Technical Information

Ref No. : ZSL00006

Expanding TX Frequency Coverage for the IC-7000(#02)

Diode Matrix Condition on the MAIN UNIT

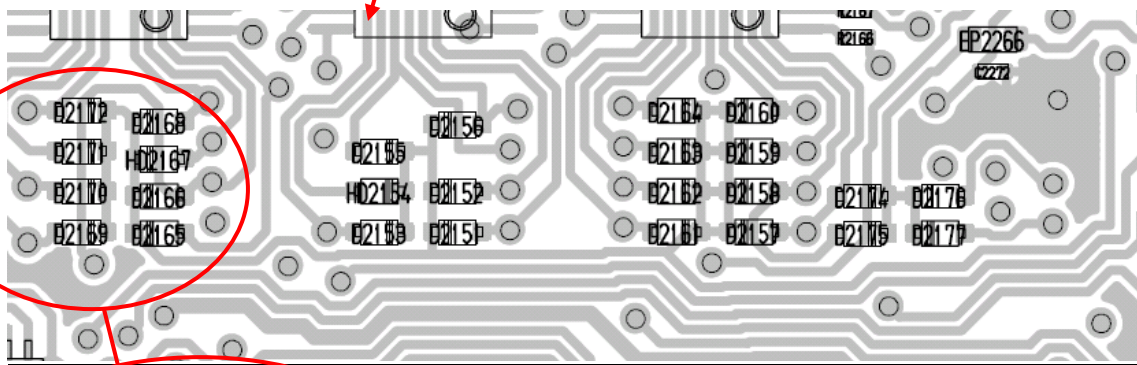
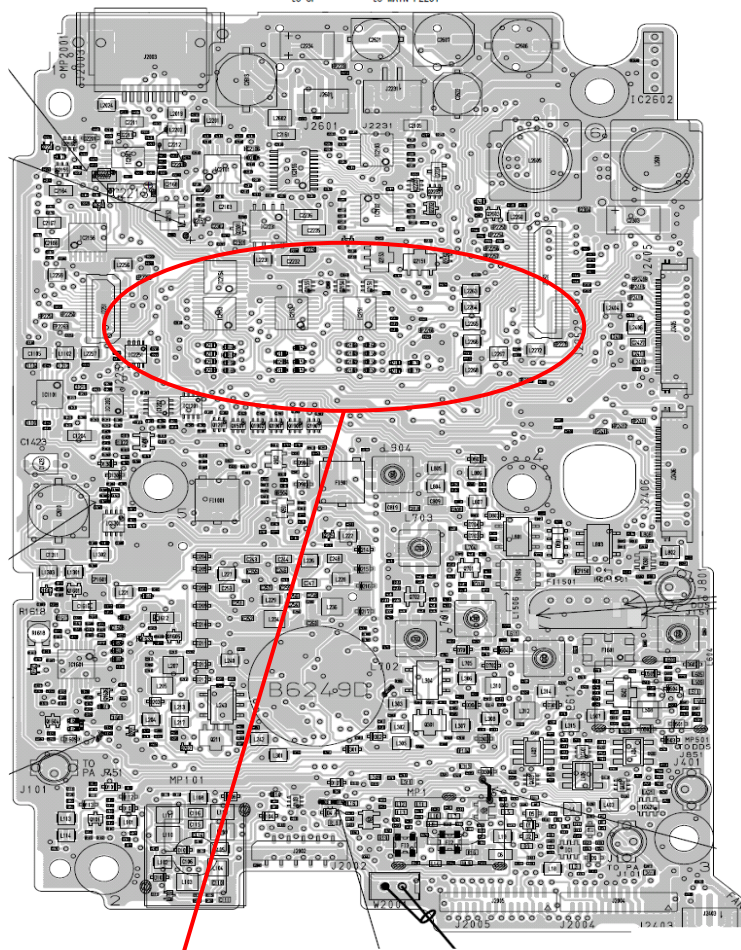
Following information is regarding the modification of expanding the TX frequency coverage of the IC-7000

D2168	D2169	D2170	D2171	D2172	
1	NO	NO	NO	NO	NO	1.6 – 25.999999 MHz 28.0 – 29.999999 MHz 50.0 – 54.000000 MHz 144.0 – 146.000000 MHz 430.0 – 440.000000 MHz
2	NO	YES	NO	NO	NO	1.6 – 54.000000 MHz 118.0 – 174.000000 MHz 400.0 – 470.000000 MHz
3	NO	NO	YES	NO	NO	0.1 – 199.999999 MHz 400.0 – 470.000000 MHz
